Our reference 2112699A-LT_2519/TVD:kd

Neuroscience Research Project - Outstanding Information

Appendix A – Revised Project Designs

Drawing Number
PA-201-2D

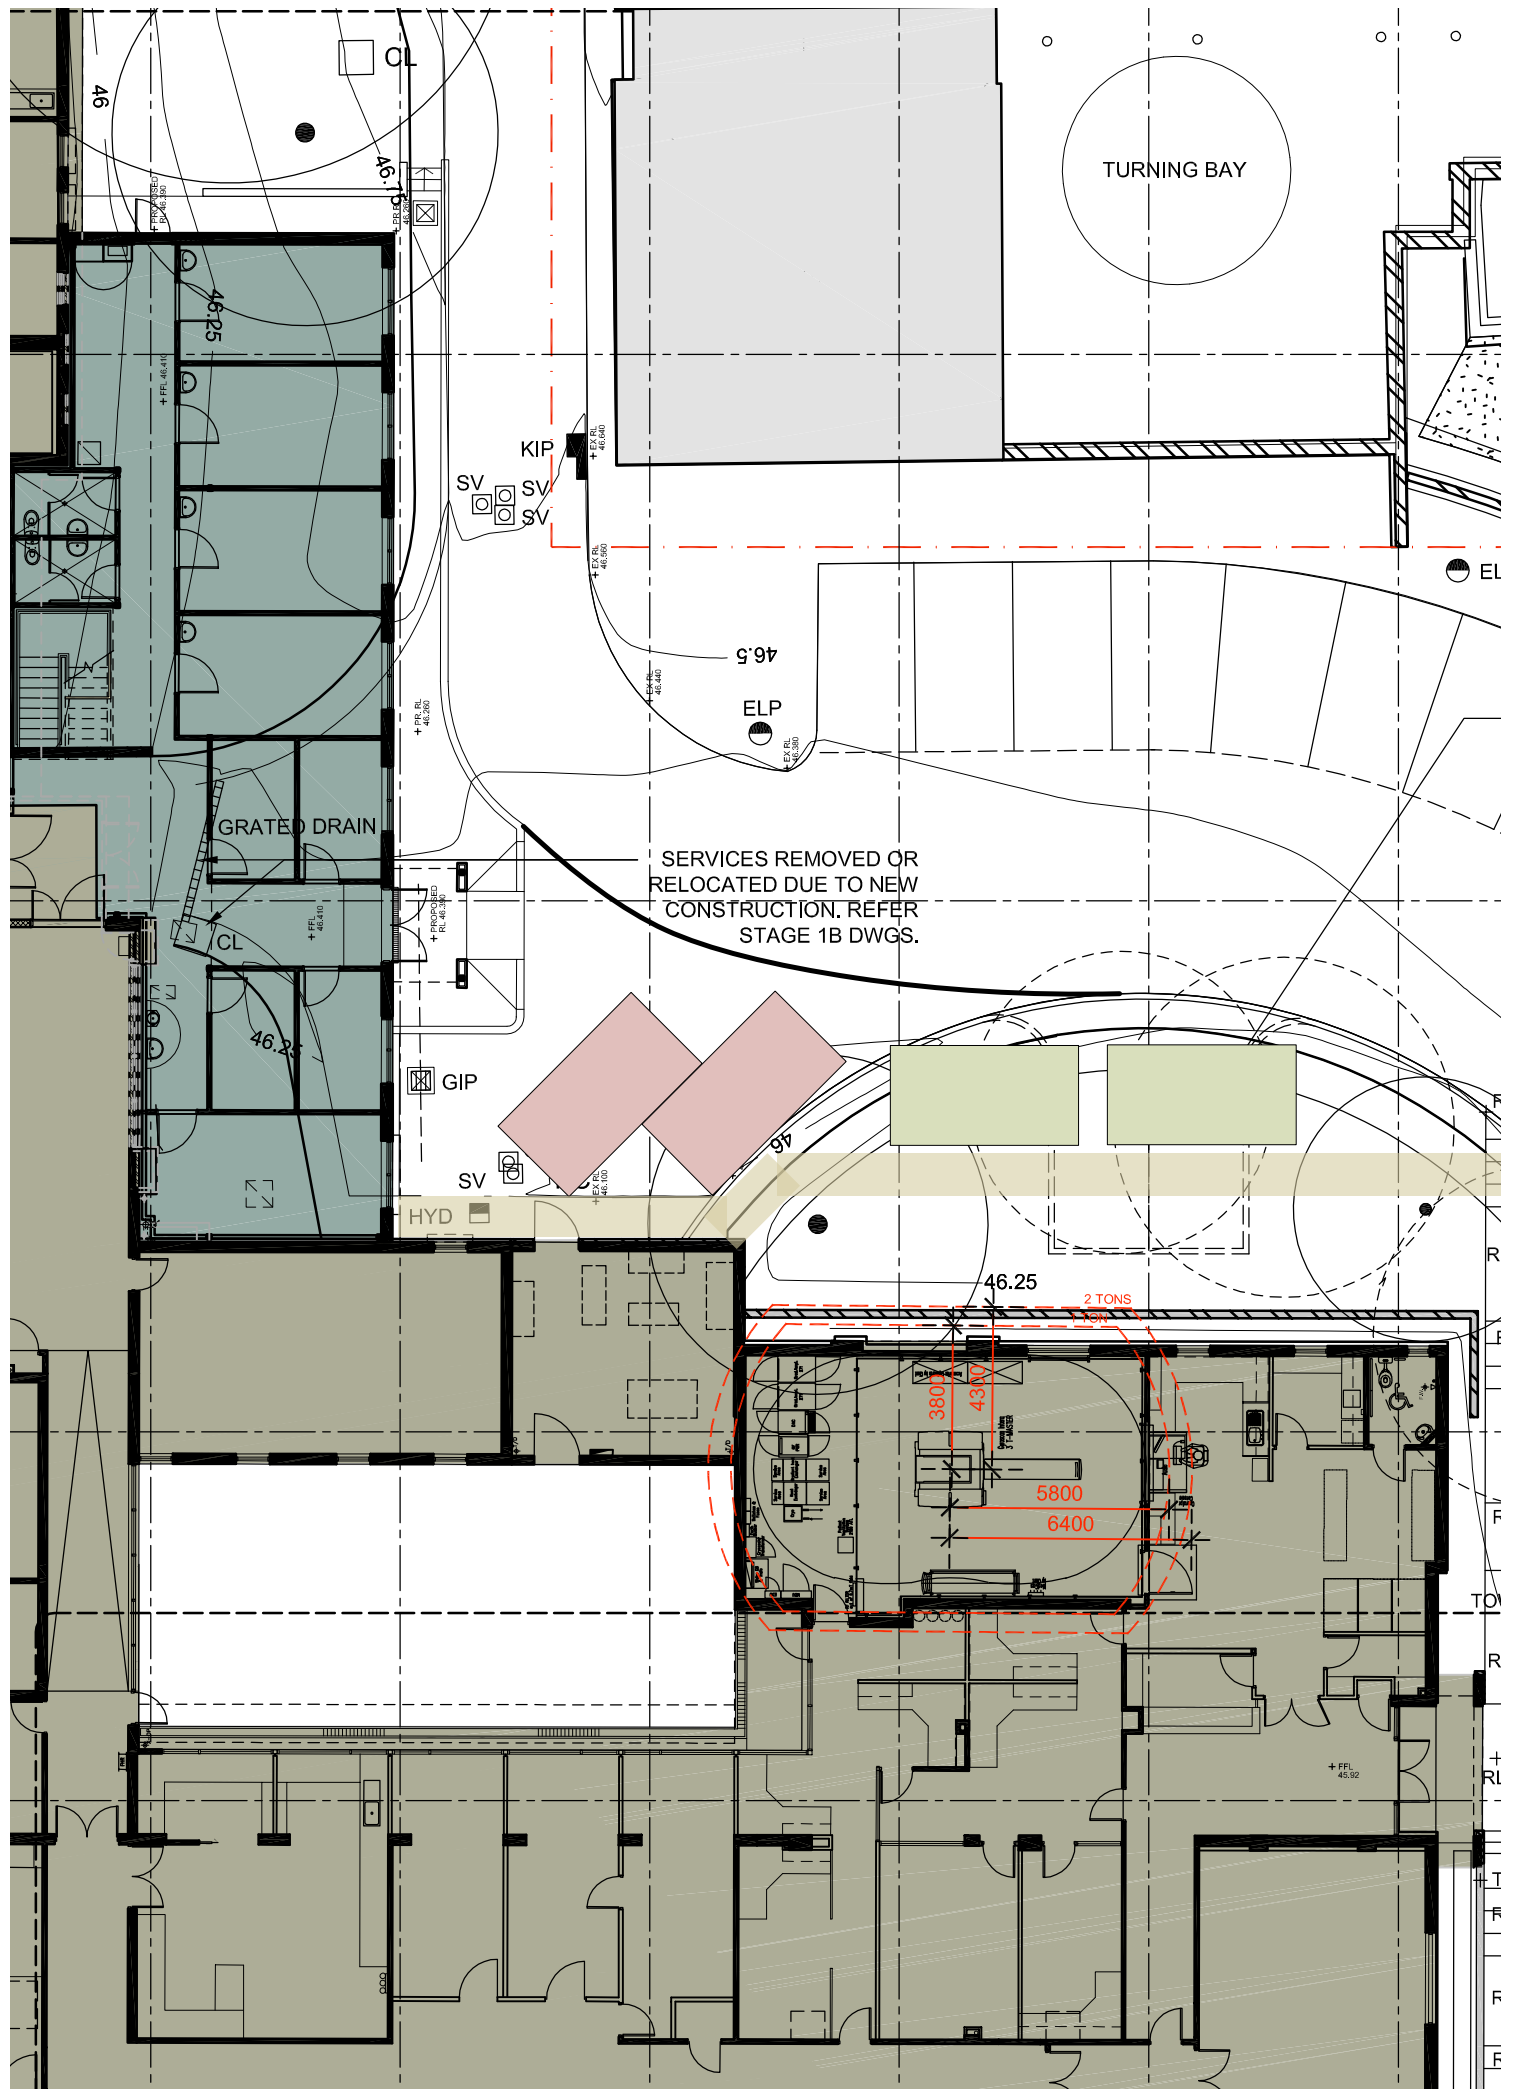
PB have been advised that the location of the ramp from Easy Street into the at-grade parking area has changed for Stages 2A and 2B (see figure in Appendix A). The changed ramp design will require two parking spaces to be moved. A replacement location has been found next to the existing building (see Appendix A). Therefore there is no net change from the parking numbers presented in the Traffic Study and TMAP (February 2009).

5.94 m Ambulance and
6.4m Ambulance test

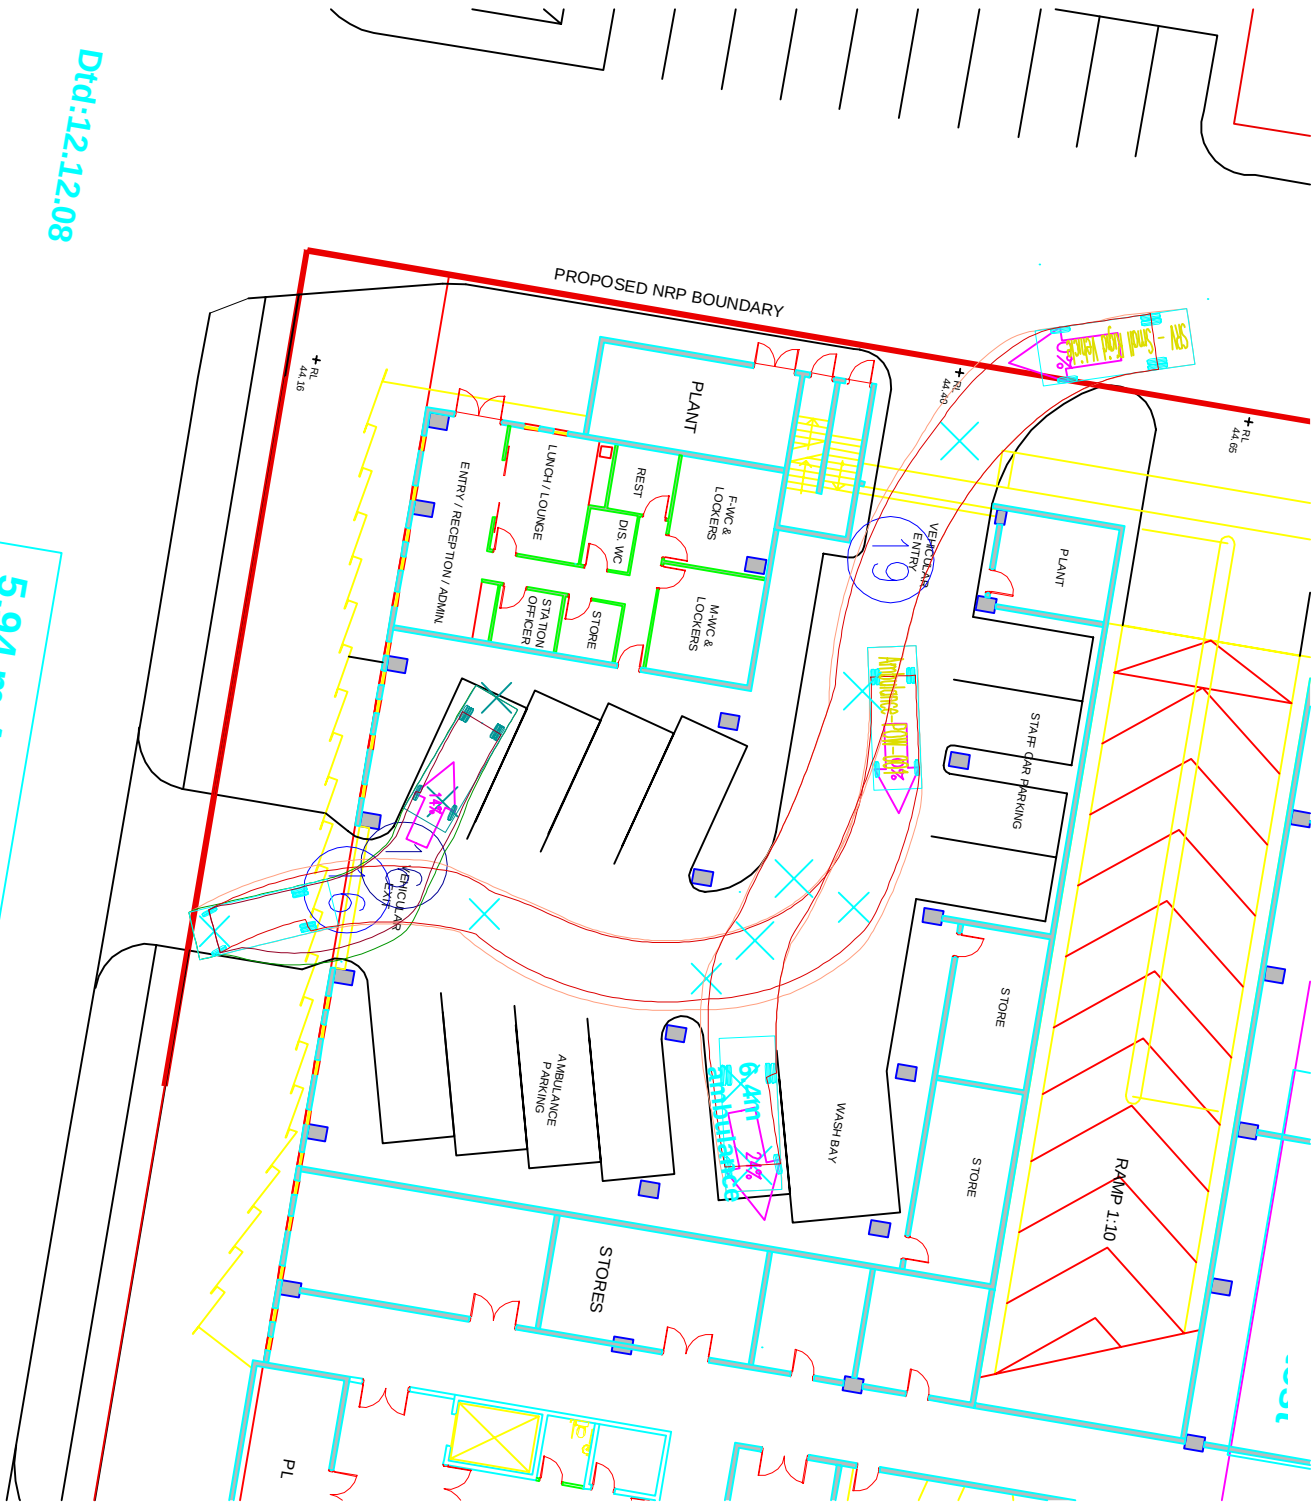
Ambulance station	5.94 m + 6.4 m Ambulances	Both ambulances can make all turns and access all parking spaces in two movements. Spaces closest to Barker Street exit can only be entered with front door open. Only one 6.4m ambulance to be accommodated in larger parking space.
Interim construction stage car park	AUSTROADS Car/Van (5.2 m long)	Car can make all turns necessary.

Stage 2A At-Grade Car Park Austrads Car

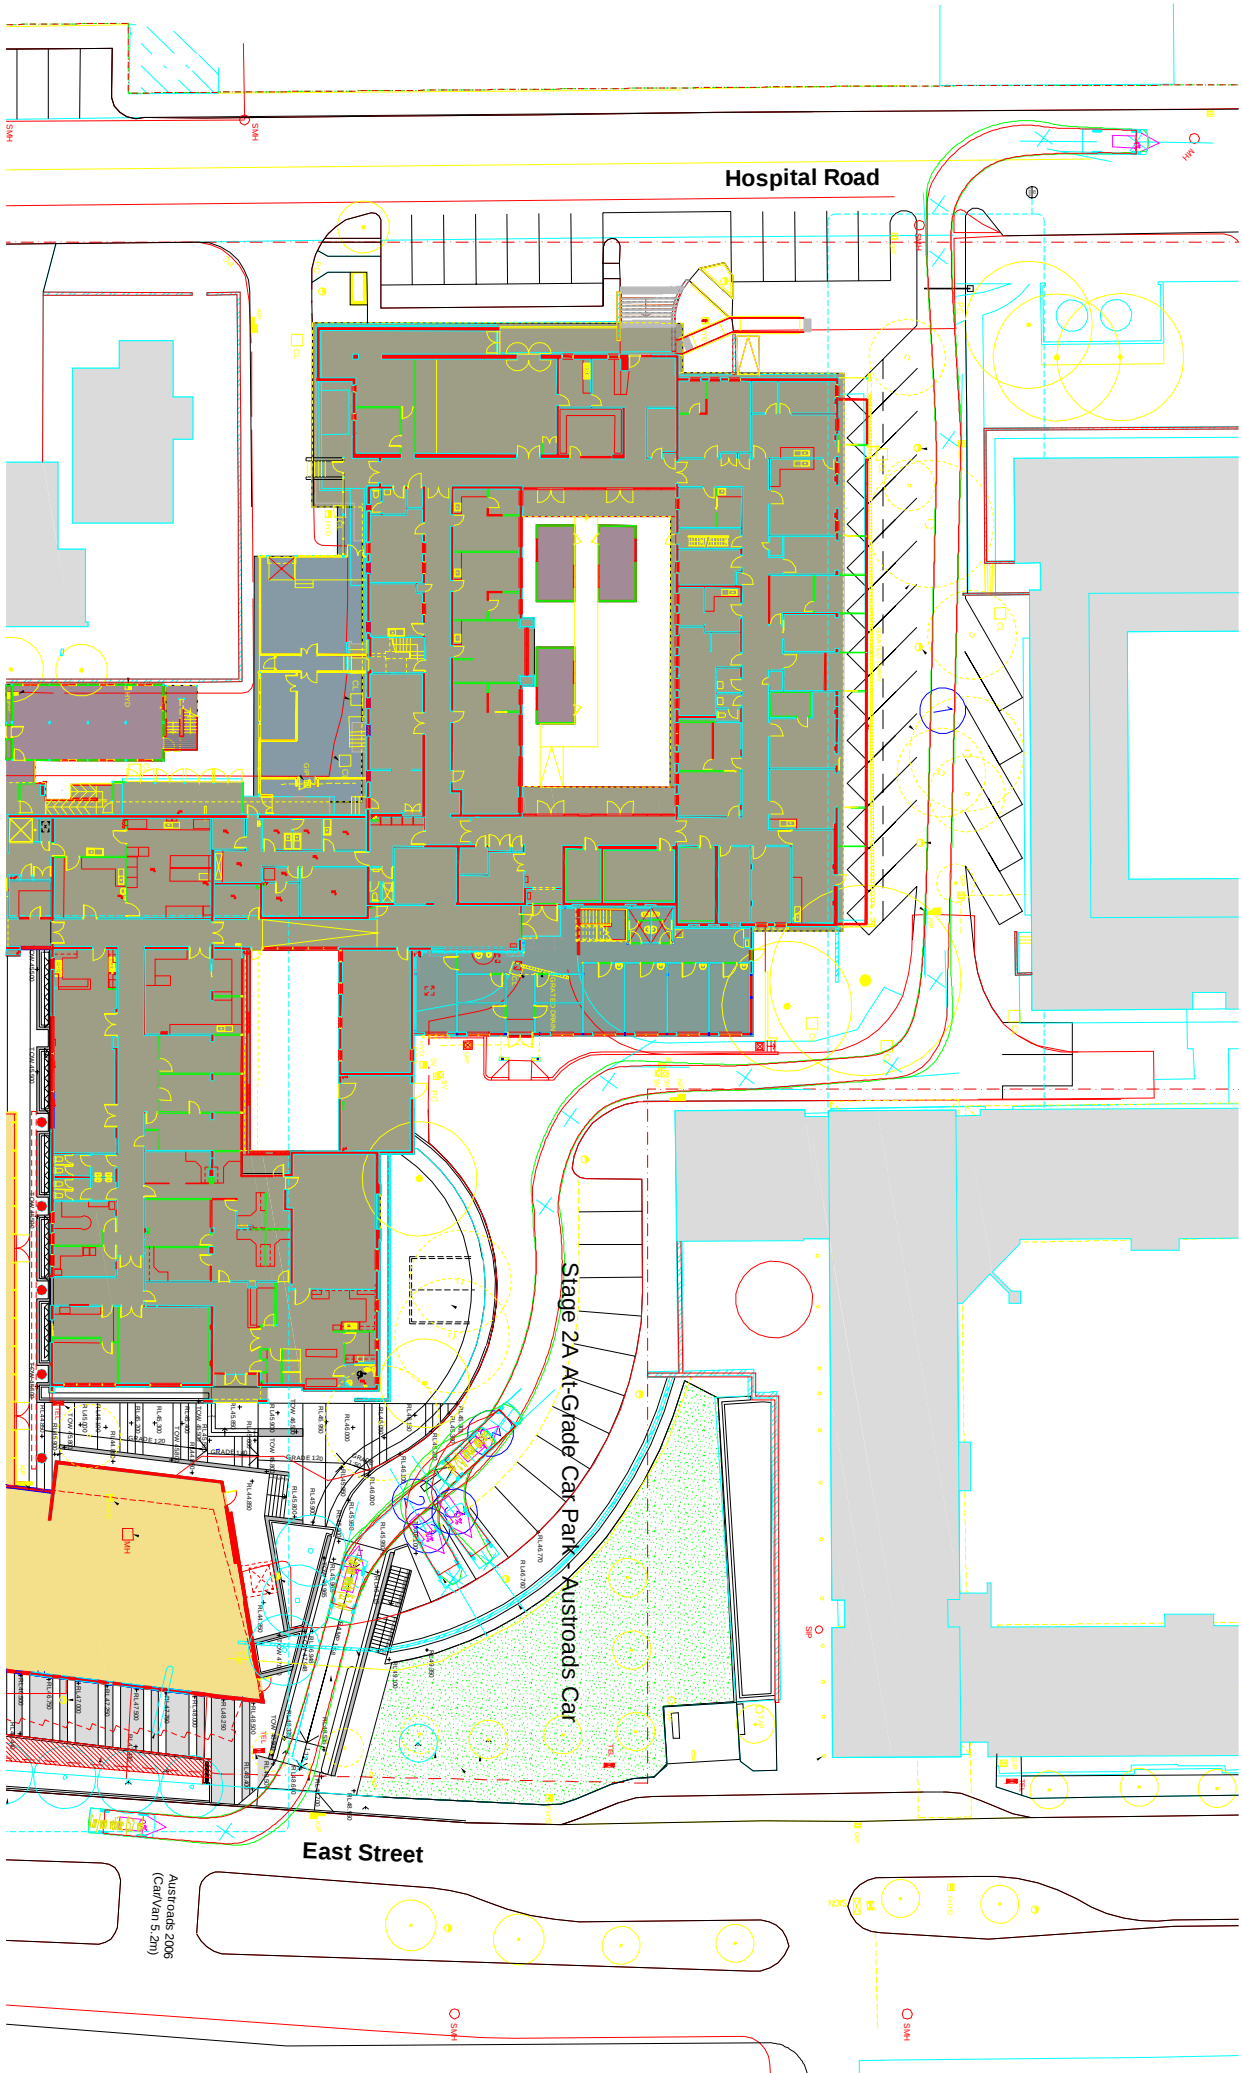
The turning path analysis has been replicated for the new ramp entry arrangements. The new entry is still acceptable. In fact, it has easier turns than the previous design. The results are shown in Appendix B.
